LEARNING CARE ACADEMY JSP15-57

Public hearing at the request of ICAP Development for recommendation to the City Council for Concept Plan approval under the Planned Suburban Low Rise Overlay District. The subject property is located on the west side of Beck Road north of Eleven Mile Road (Section 17). The applicant is proposing a child care facility to serve up to 170 children.

Planning Review

PSLR Concept Plan

SHEET NUMBER
C2.0

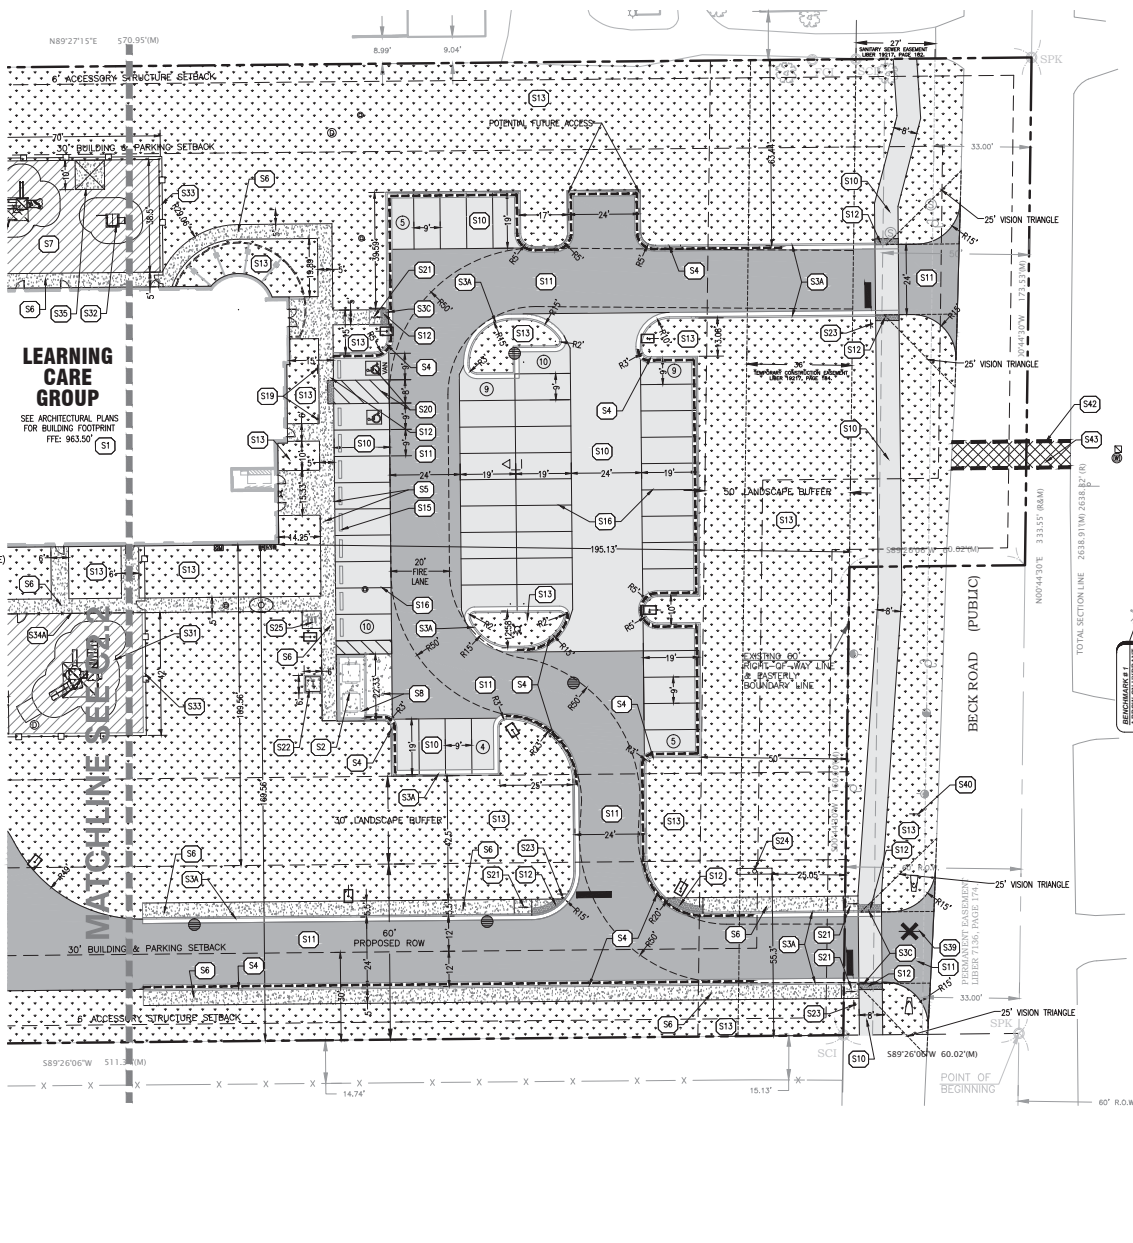
- f. The applicant updating the PSLR concept plan submittal to include the proposed phase lines and revised building elevations to include the future expansion as part of the PSLR concept plan, that were provided in electronic format for staff review;

- a. Revised site plan showing the future building footprint
 - b. Phase lines, as applicable
 - c. Revised building elevations to verify conformance
2. Building, Parking and Accessory Setbacks (Sec 3.1.23.D): The site plan indicates the setbacks measured from the existing property line. **The setbacks are required to be measured from the proposed Rights-of-way after dedication. Please revise the drawings to indicate the same.**

RIGHT (NORTH) SIDE ELEVATION
SCALE: 1/8" = 1'-0"

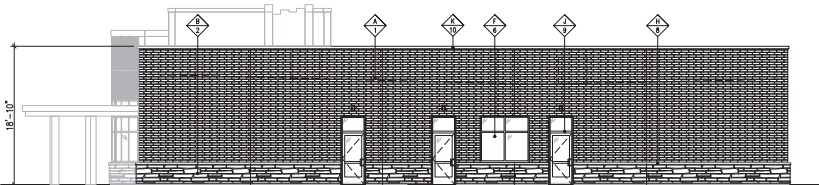
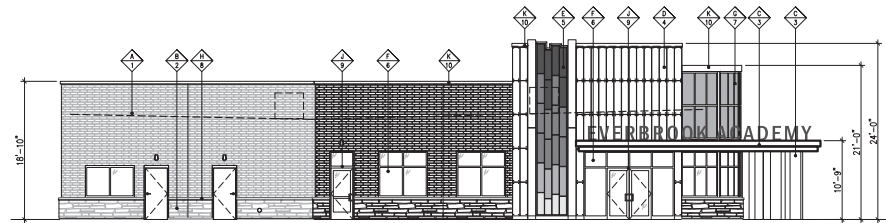
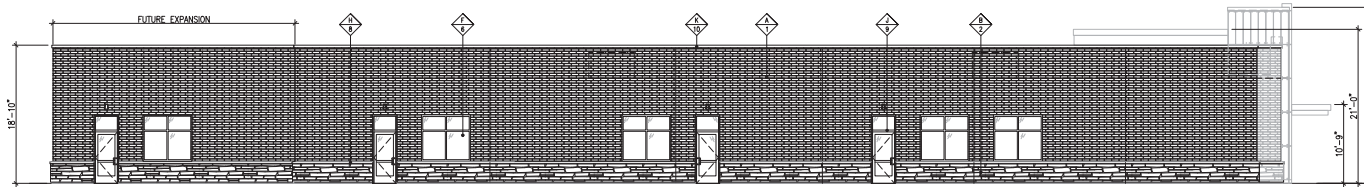
Building Design Standards (Sec. 3.21.2.C)				
Building Height (Sec. 3.21.2.C.i)	35 ft. or 2 ½ stories	Maximum height is noted to be kept at 24 ft.	Yes	Label maximum building height on elevations
Building Design (Sec. 3.21.2.C.ii)	Buildings must be designed with a "single-family residential character"	The proposed building meets the intent of the PLSR district	Yes	Refer to Façade comments for the further details
Maximum % of Lot Area Covered	25%	Not provided. The site plan appears to	Yes?	Provide the maximum percent of lot covered buildings including
